ADDENDUM 01, DELTA 01

DATE 01.30.2026

PROJECT: Santa Rosa Freestanding Emergency Room

ARCHITECT'S PROJECT NUMBER:
225014.00

FLOOR PLAN -
NOTED

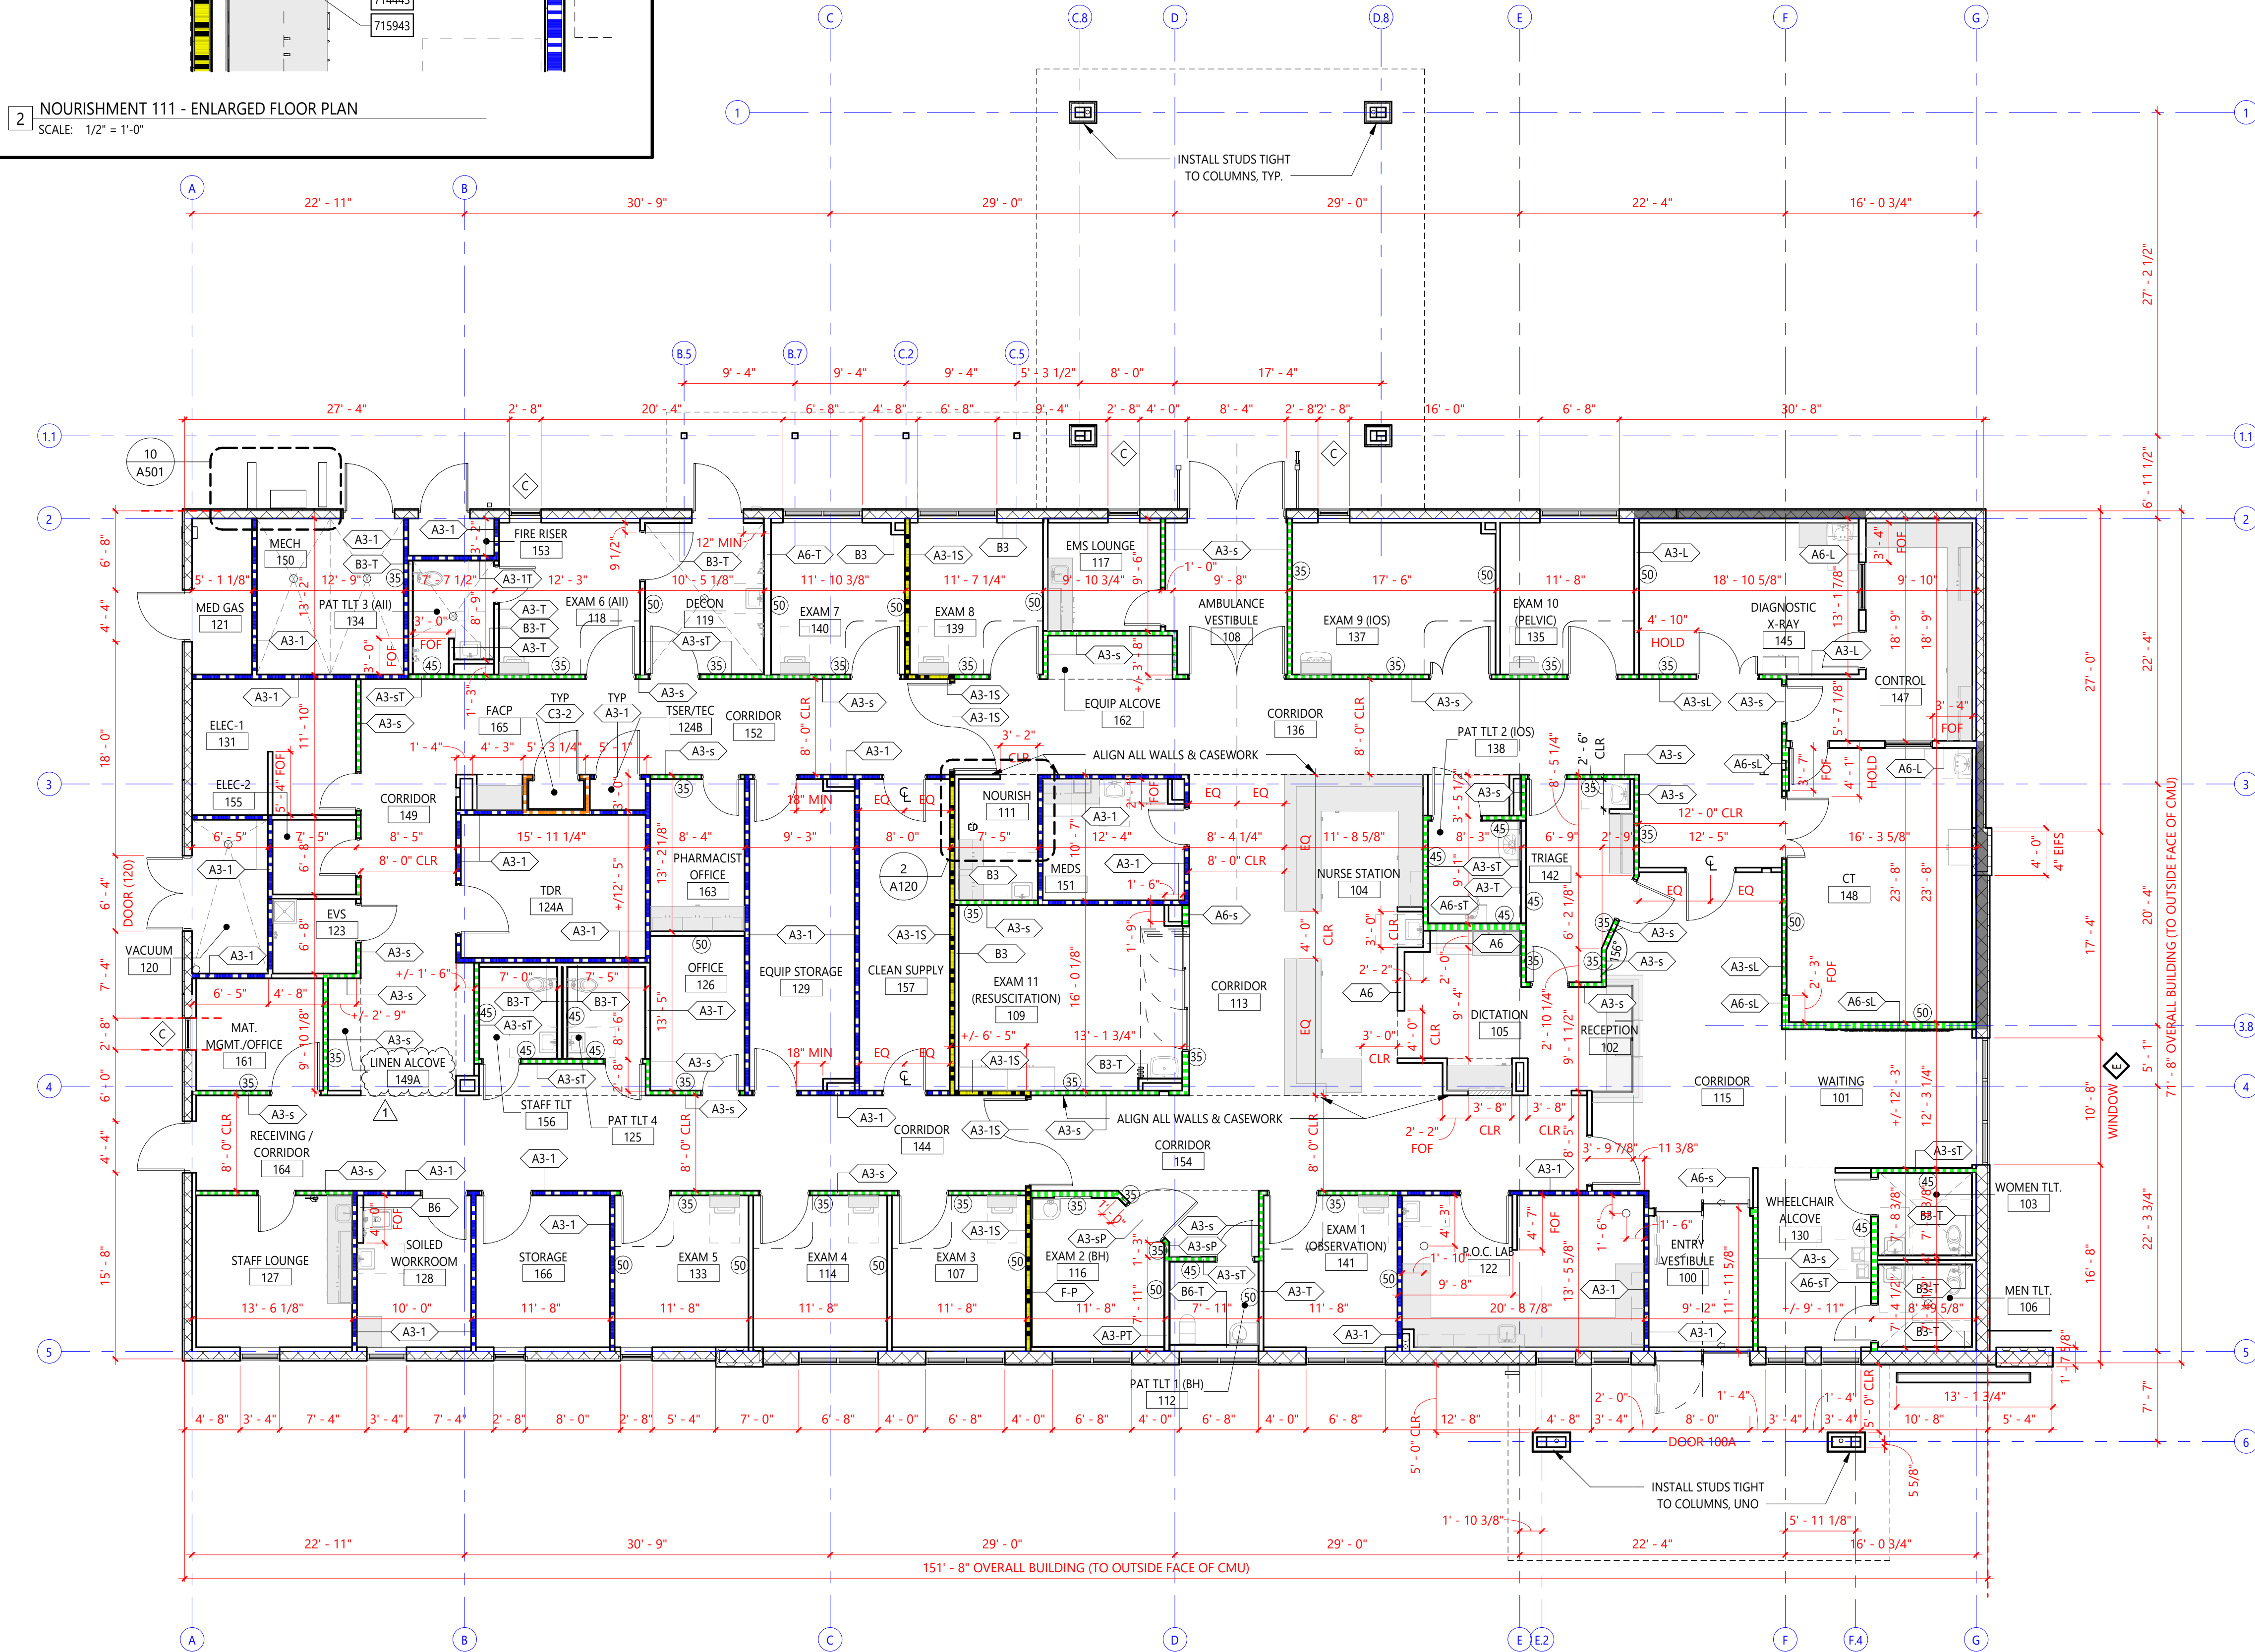
1. Reference "Floor Plan Notes:"
 - a. Added "POC – Point of Care" to the list of room name abbreviations per AHCA Stage II review comment. No scope of work change.
2. Reference "Partition Fire Rating Legend:"
 - a. Revised the definition of the smoke barrier to read: "Smoke Barrier (1-HR)" for additional clarification.
3. Reference Detail 1: "Floor Plan – Noted:"
 - a. Added interior elevation view in the corridor outside the Staff Lounge to indicate the installation height and locations of the employee time clock and jumpstart device. Jumpstart device added per client direction.
 - b. Room tag added to indicate the location of the linen alcove per AHCA Stage II review comment.

A131

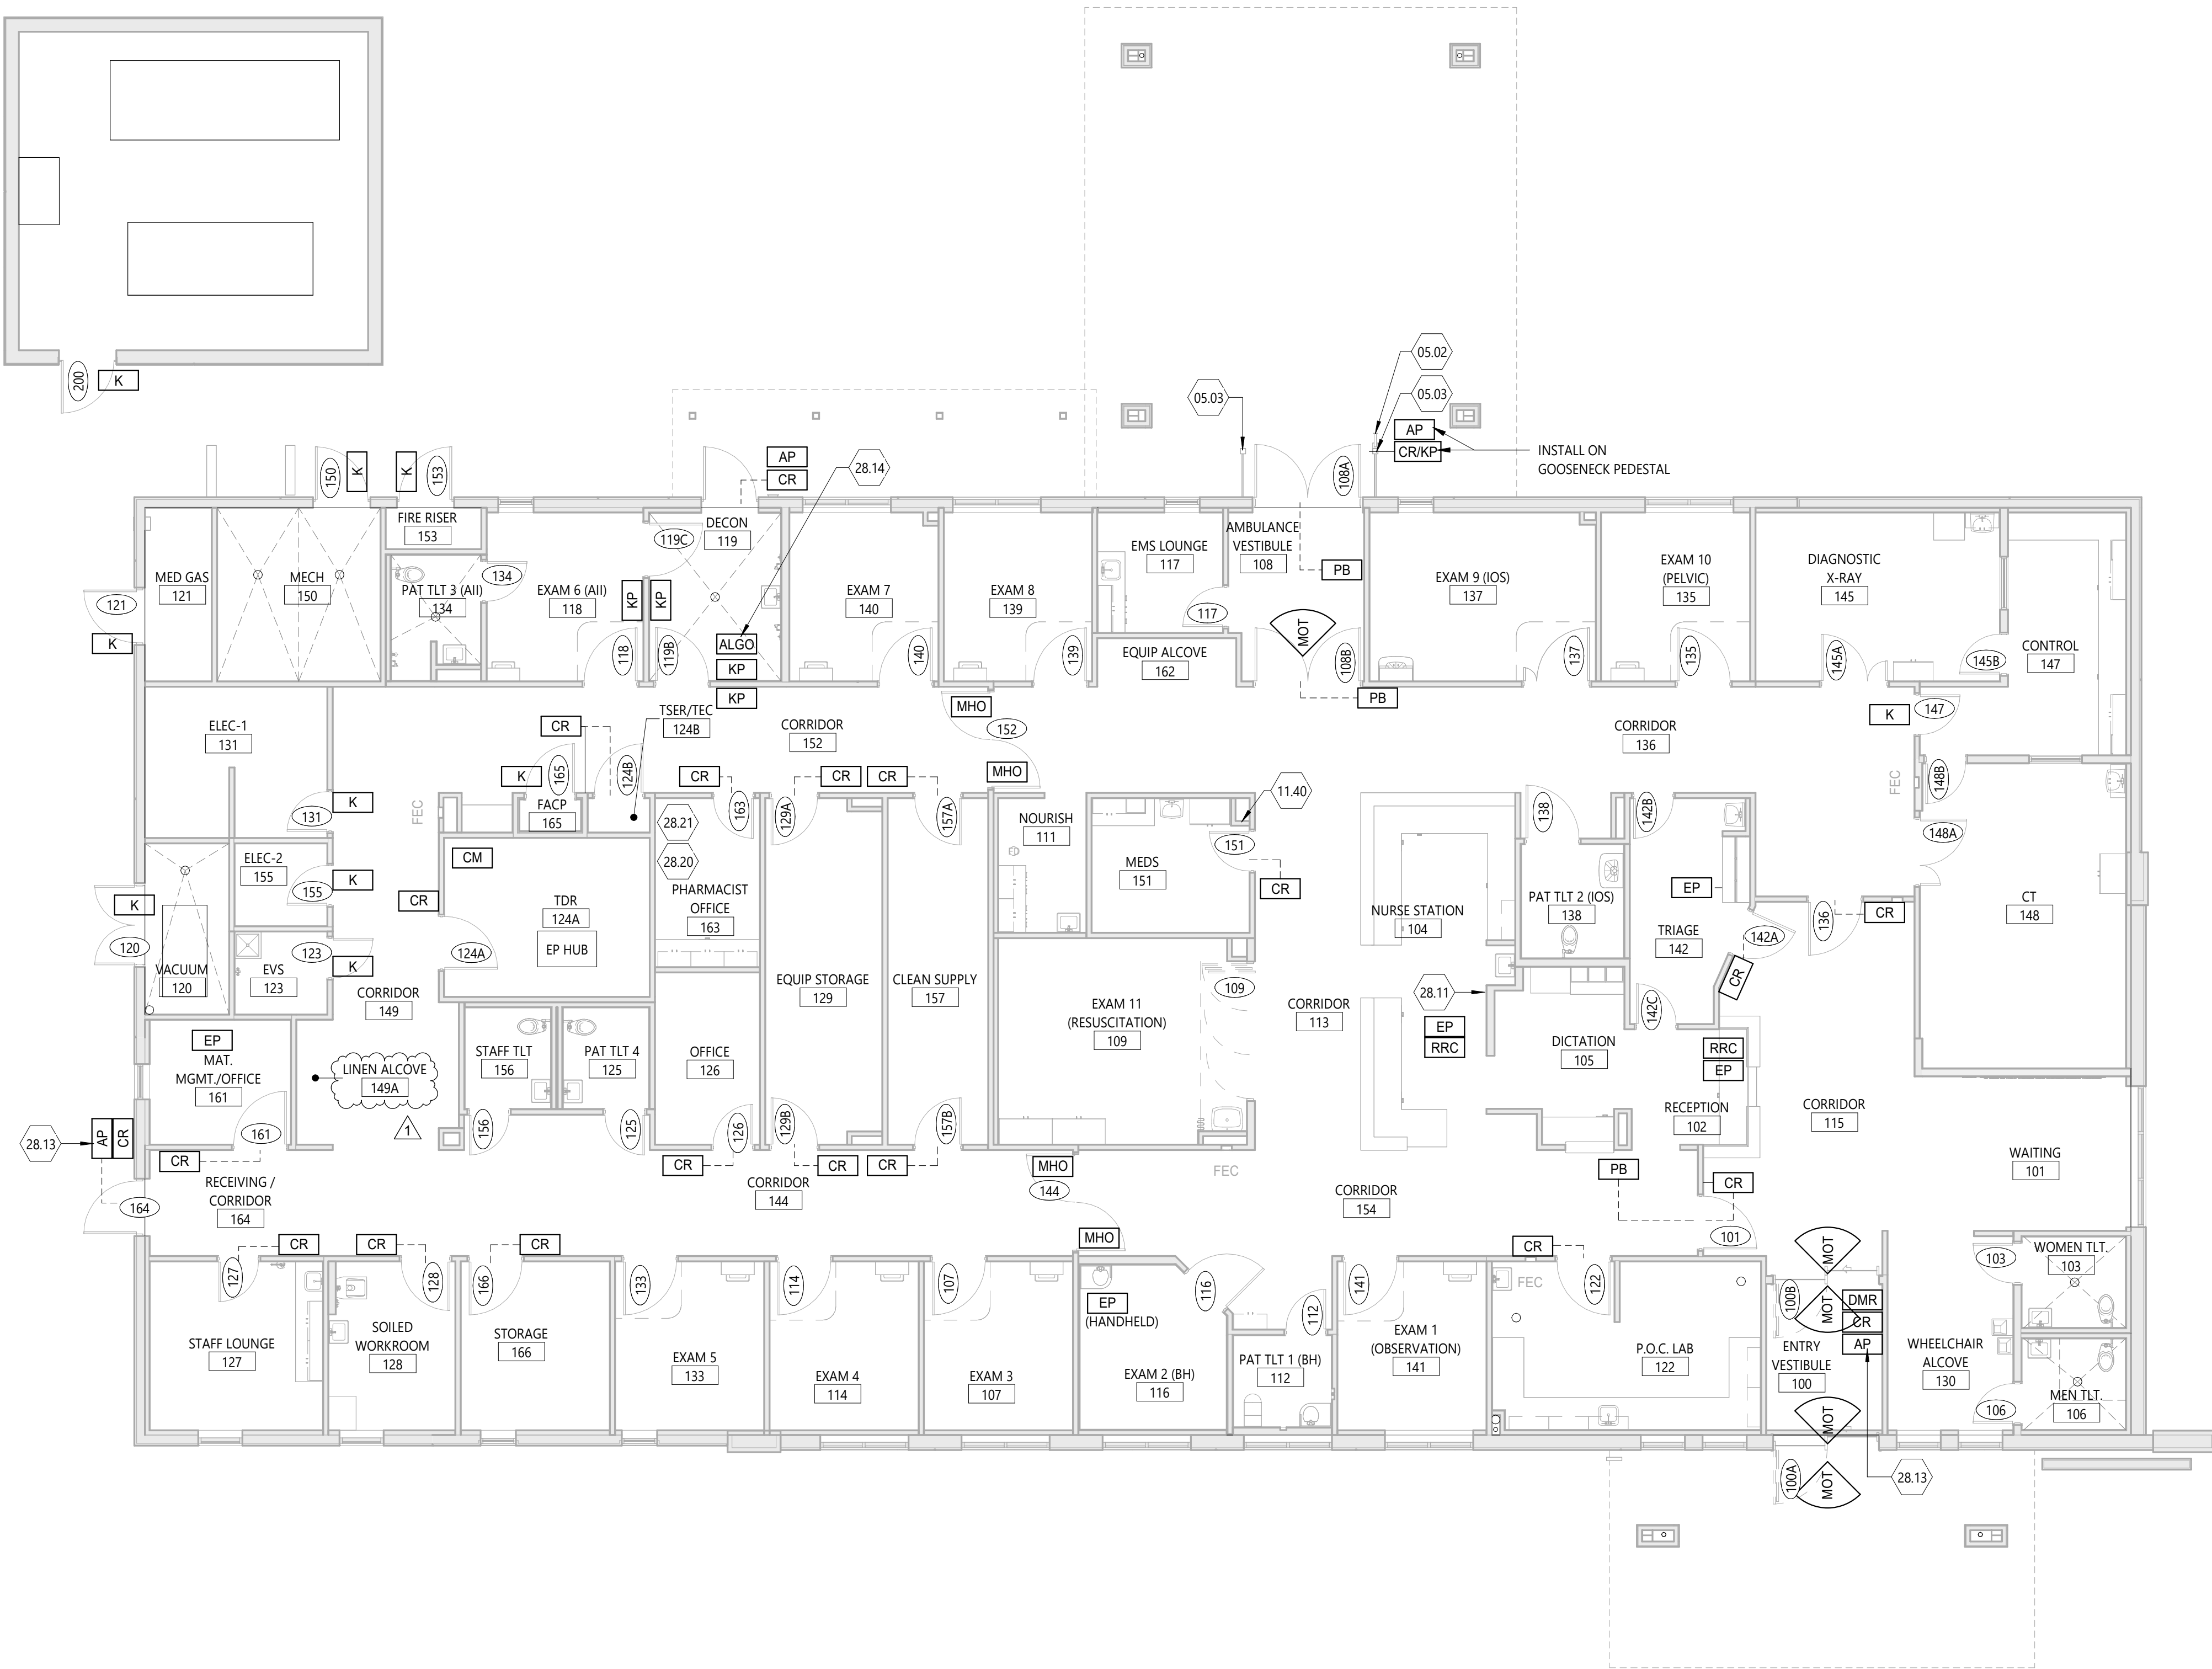
1. Reference "Medical Equipment List:"
 - a. Revised the responsibility indicators for the employee time clock (EQ27) and the jump start device (EQ88) for additional clarification.

SHEET
A140

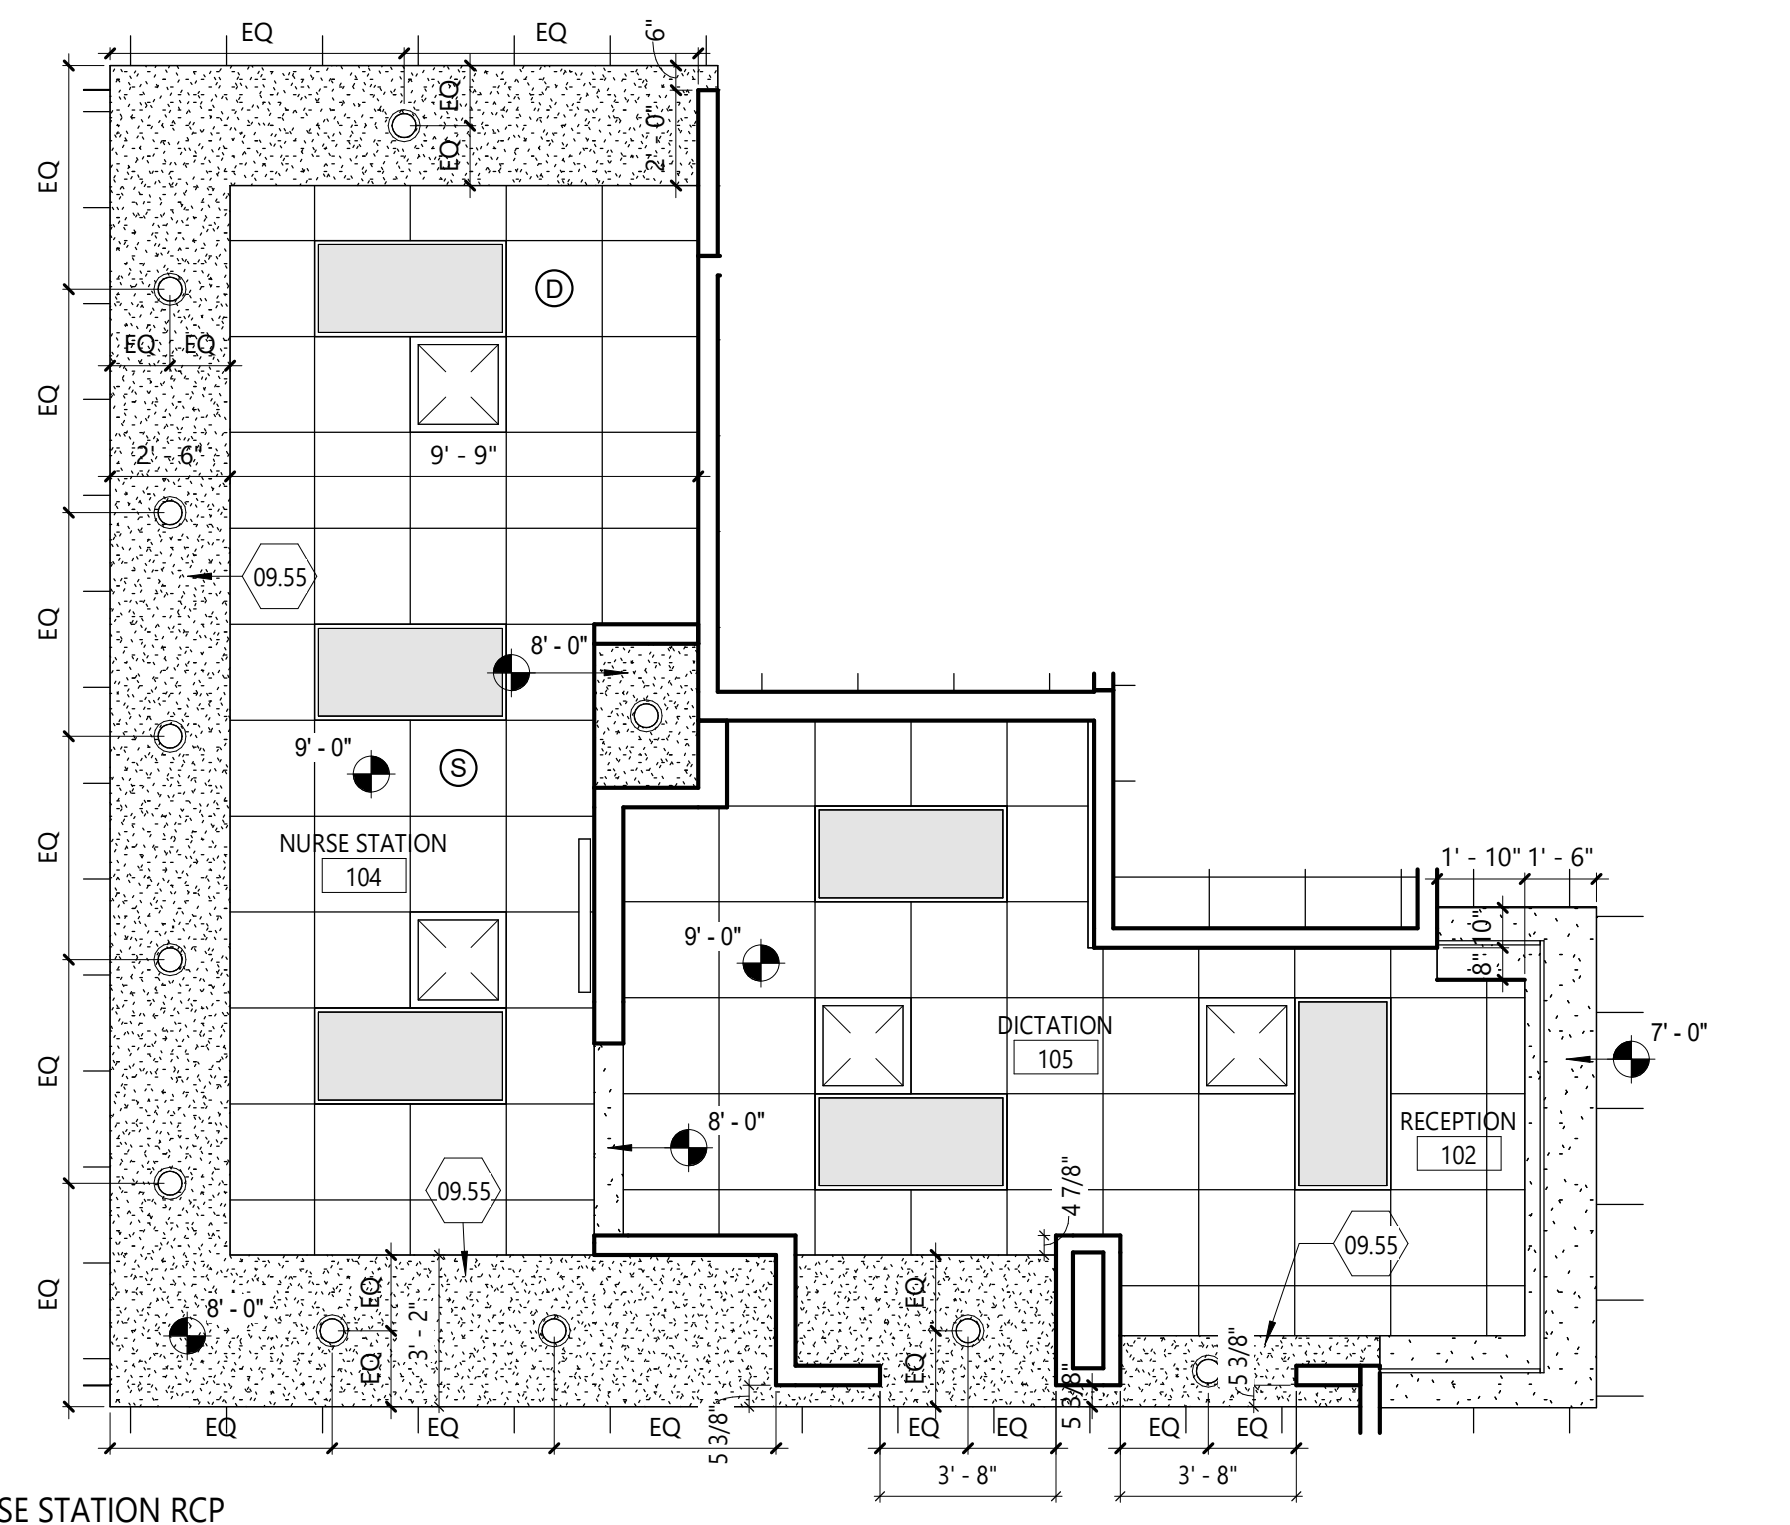
1. Reference Detail 1: "Floor Plan – Access Control:"
 - a. Room tag added to indicate the location of the linen alcove per AHCA Stage II review comment.
